INFORMATION SHEET 8/18/15 TRUSTEES MEETING

ISSUE: RGM Associates Jefferson Change Order #'s #086, #088, #093, #095- #097 and Traina Gymnasium Change Order #'s #020, #024- #026

RE: Jefferson School Replacement
DSA Appl. #: 02-113192
COR #086

PROJECT: Jefferson Replacement Project
7500 West Linne Road
Tracy, CA 95377

Drawing Number
FP-4.1SK

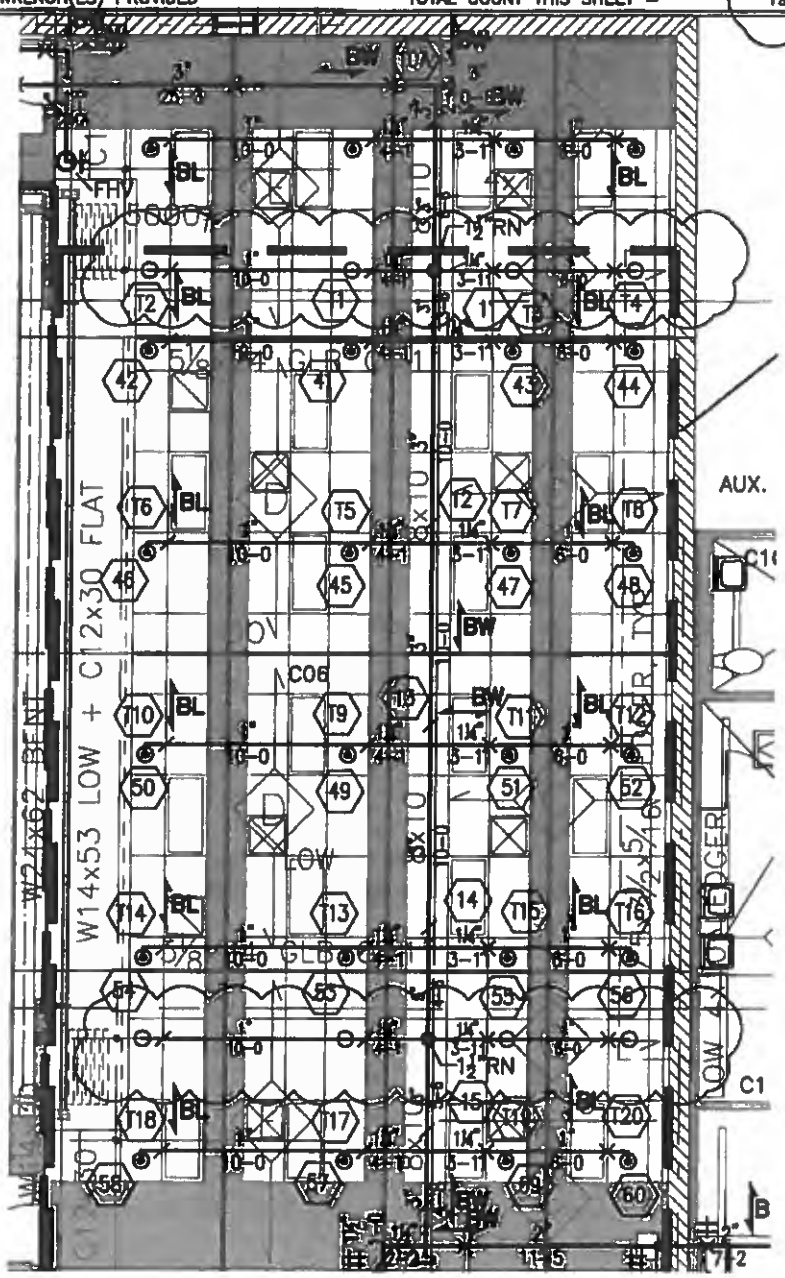
Description: Bldg. C Fire Sprinkler Spacing @ Room C06

Question:
Branch lines over room "C06" (stage area) between grid lines 2 & 5, B & C, do not provide proper coverage. Branch line spacing with Upright Fire Sprinkler heads is not symmetrical to structural Glue-lam spacing. Existing branch line layout is being obstructed by the Glue Lams that are adjacent to grid lines 3 & 4.

Response: Add eight (8) Upright Sprinklers added over rm. C06. Two (2) Uprights from RFI 319 will be installed in RFI 323

Response: Eight Upright Sprinklers added over room C06.

Drawing Number
FP-4.2SK

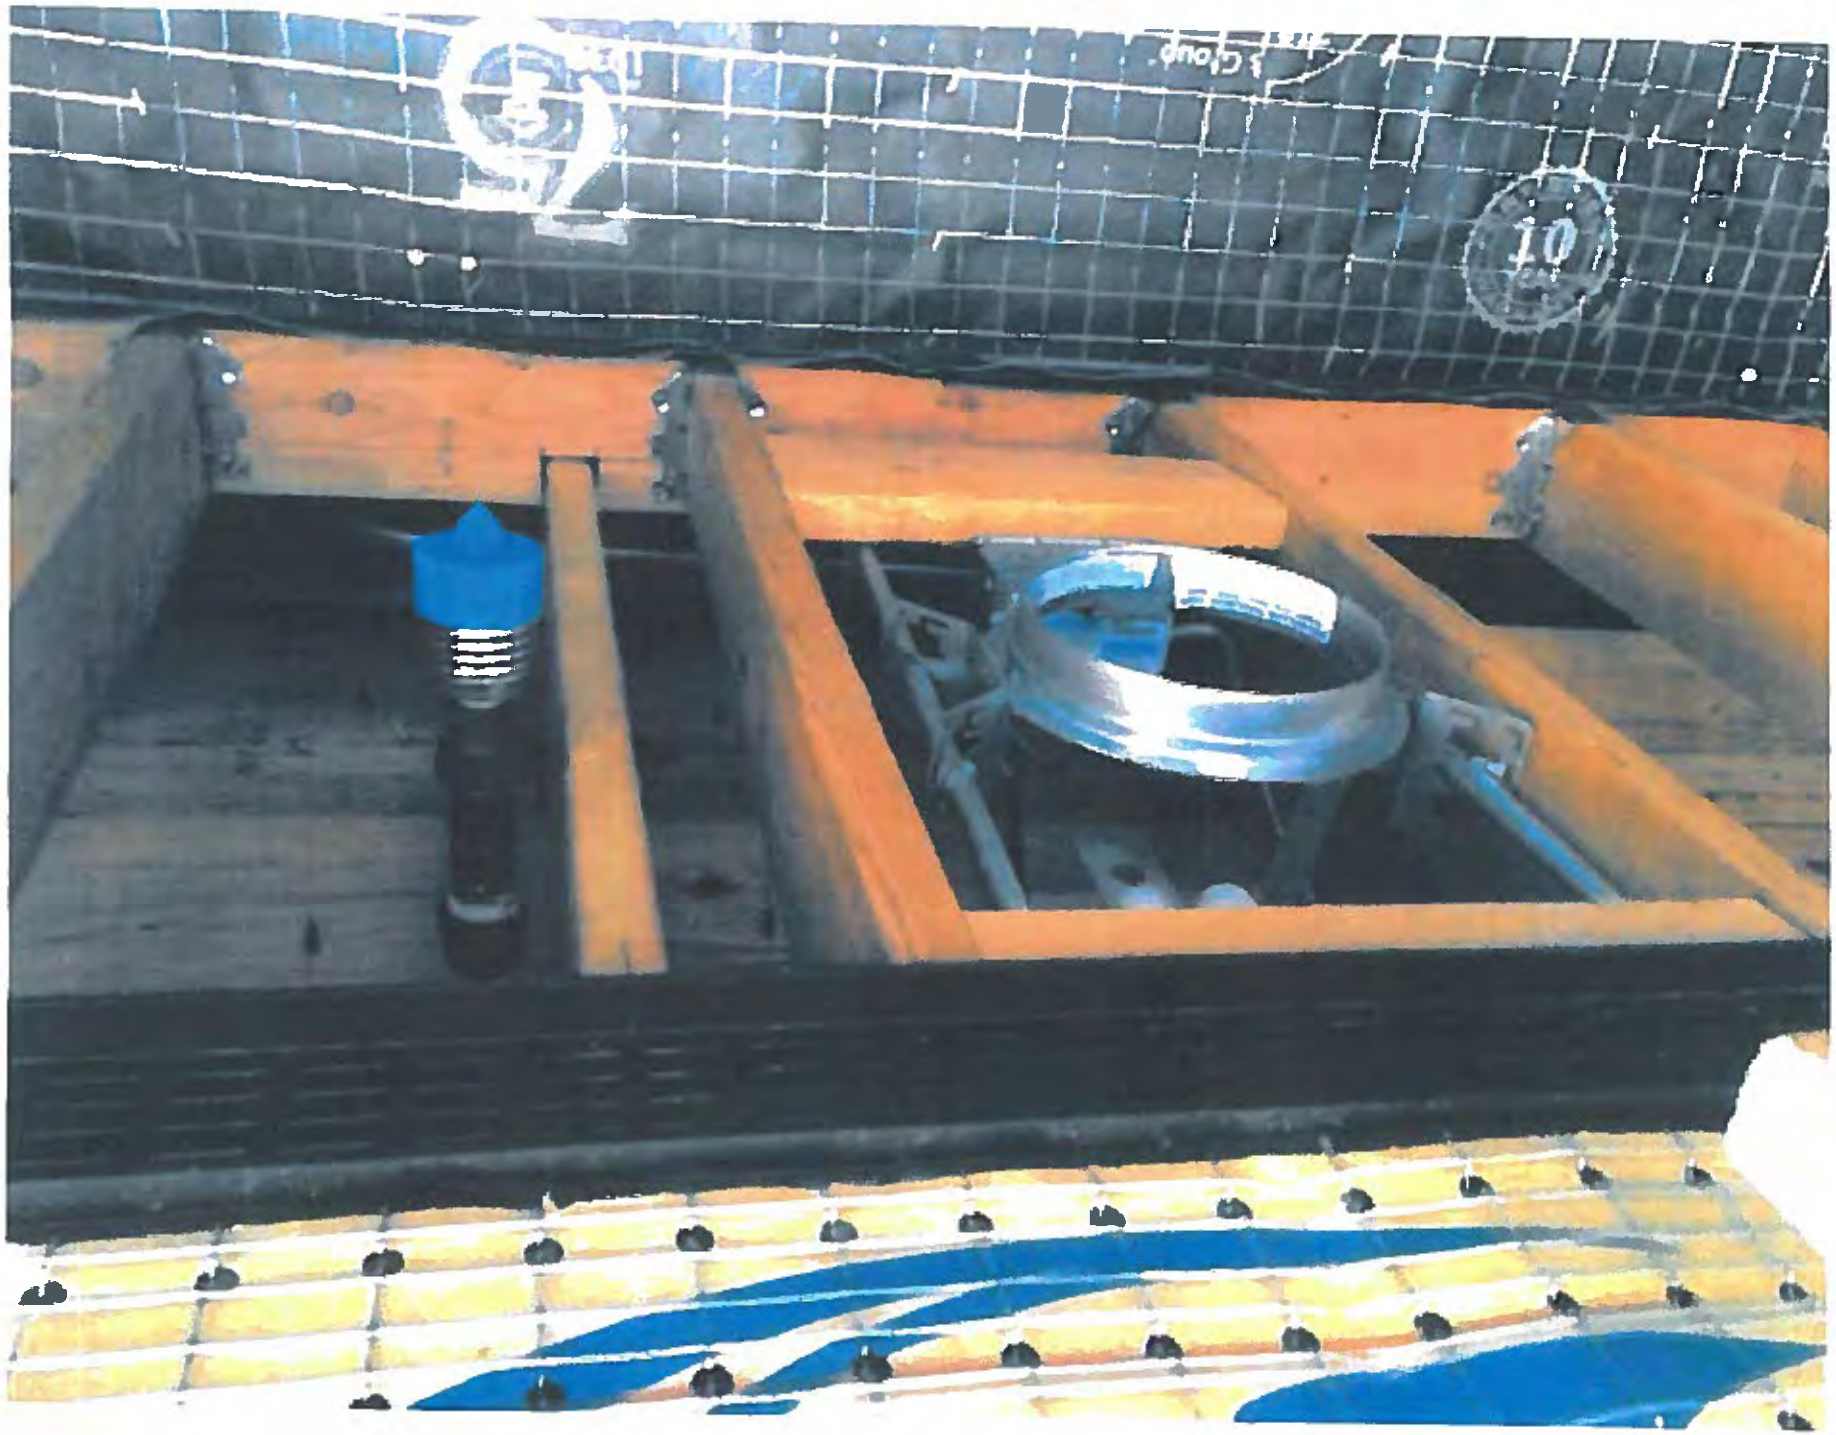
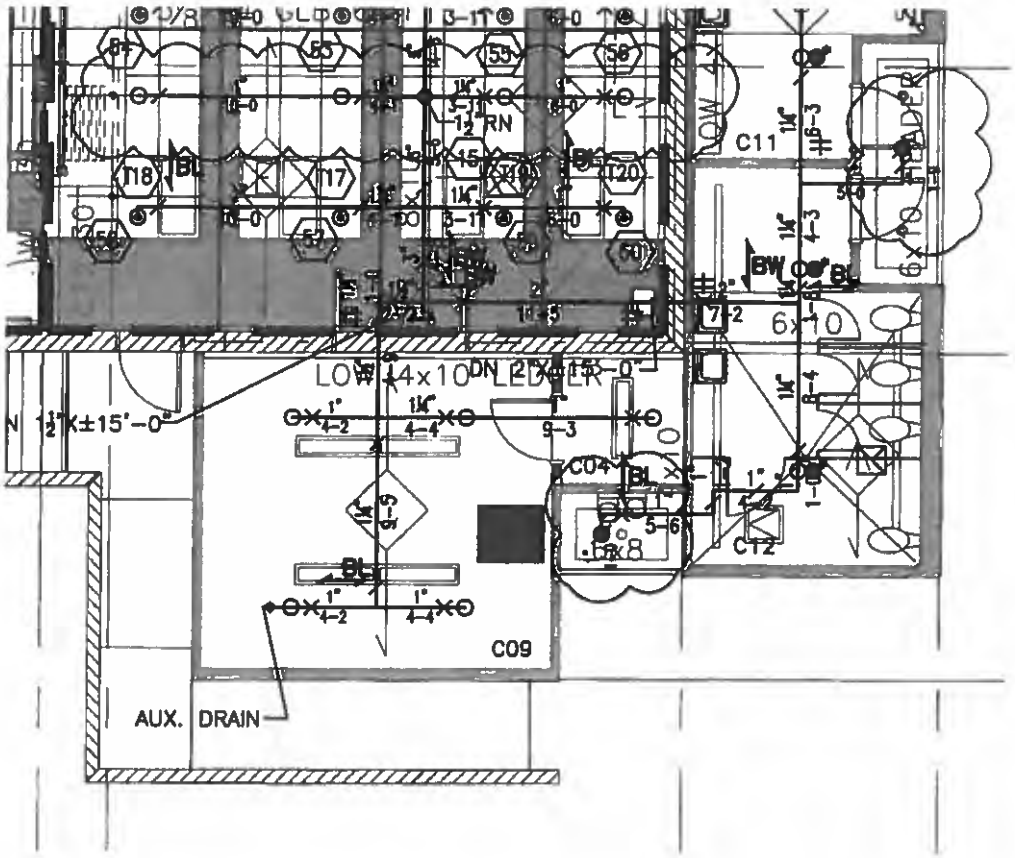
Description: **Fire Sprinklers at Bldg. C Drinking Fountain &Restroom Alcoves**

Question:
Please reference fire sprinkler drawing FP-4. Upright fire sprinkler heads are shown in the ceiling area of the drinking fountain alcove located between 5 and 6 line at the intersection of B line. Upright sprinklers are also shown in the ceiling of the restroom alcove at grid A between lines 4 and 5. Please see attached photos of these locations that show there in under 6" of space between ceiling and roof framing. Please advise if these upright heads are needed at these locations.

Response:
Omit Upright Sprinkler in the ceiling area of the drinking fountain alcove located between 5 and 6 line at the intersection of B line. Omit Upright Sprinkler in the ceiling of the restroom alcove at grid A between lines 4 and 5. Concealed spaces formed by ceilings attached directly to or within 6 in. of wood joist or similar solid member construction shall not require sprinkler protection in accordance with NFPA 13-2010, section 8.15.1.2.5.
